GE Lighting

Request for Class II Permissive Change

FCC ID: PUU-CSWONBLXWF1

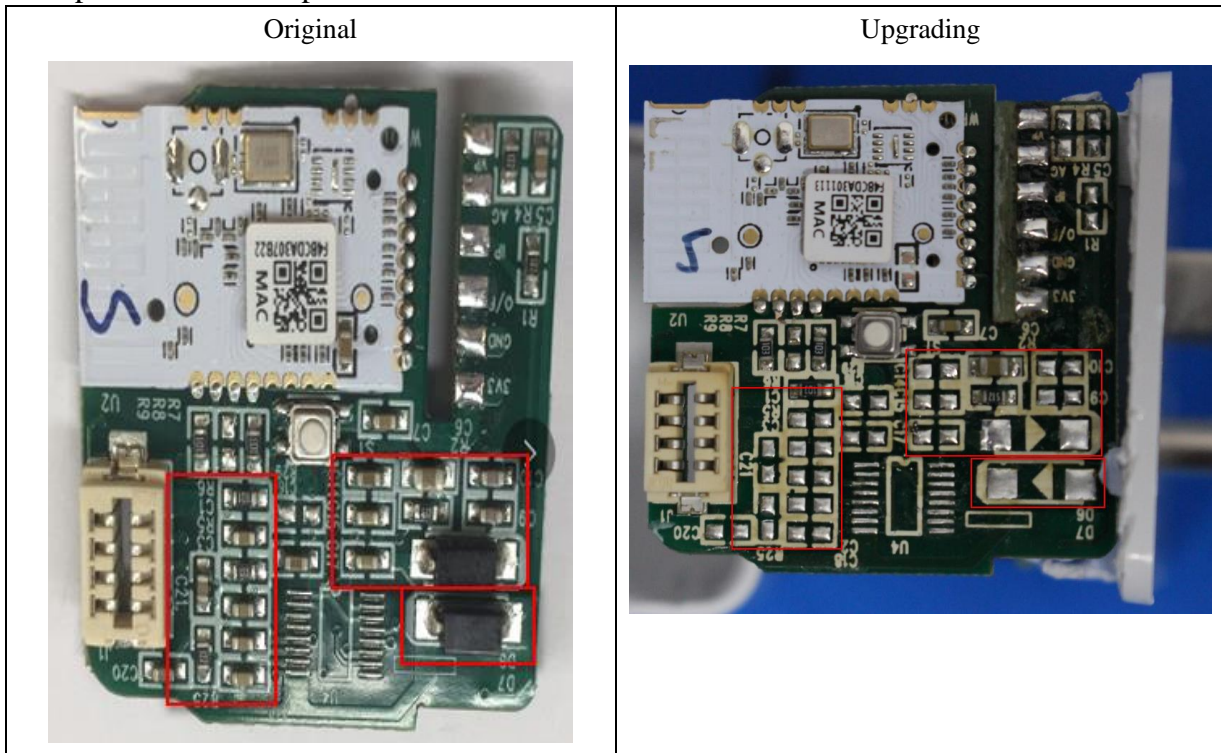
The new product only removes the IC with the bit number U4 on the WIFI board and then removes the redundant and useless peripheral related components, which will not effect the function of the product. The original product only removed the IC with bit number U4 and the peripheral related components were not processed and remained on the board.
